Economic Commission for Europe**Inland Transport Committee****World Forum for Harmonization of Vehicle Regulations****Working Party on Passive Safety****Sixty-sixth session**

Geneva, 10-13 December 2019

UN Regulation No. 94 (Frontal collision)**Proposal for Supplement 2 to the 03 series of amendments to
UN Regulation No. 94 (Frontal collision)****Submitted by the expert from the European Commission on behalf of
the drafting task force***

Figure 4

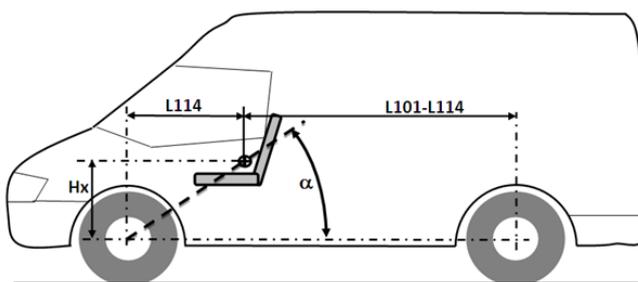
5.3.1. **Vehicles of category M₁ of a total permissible mass exceeding 2,500 kg that are based on vehicle types of category N₁ of a total permissible mass exceeding 2,500 kg are deemed to meet the requirements of paragraph 5 where the requirements of Regulation No. 137 are fully complied with and at least one of the following conditions is met:**

- (a) **the acute angle alpha (α), measured between a horizontal plane passing through the centre of the front axle and an angular transverse plane passing through the centre of the front axle and the R-point of the driver's seat (see figure 4 below), is more than 22°;**
- (b) **or the ratio between the distance from the driver's R-point to the centre of the rear axle (L101-L114) and the centre of the front axle and the driver's R-point (L114) is more than 1.30¹ (see figure 4 below).**

5.3.2. Vehicles of category N1 of a total permissible mass exceeding 2,250 kg but not exceeding 2,500 kg are deemed to meet the requirements of paragraph 5, where their structural basis is a ladder frame and the requirements of Regulation No. 137 are fully complied with and at least one of the following conditions is met:

- (a) the acute angle α , measured between a horizontal plane passing through the centre of the front axle and an angular transverse plane passing through the centre of the front axle and the R-point of the driver's seat (see figure 4 below), is more than 22° ;
- (b) or the ratio between the distance from the driver's R-point to the centre of the rear axle (L101-L114) and the centre of the front axle and the driver's R-point (L114) is more than 1.301 (see figure 4 below).
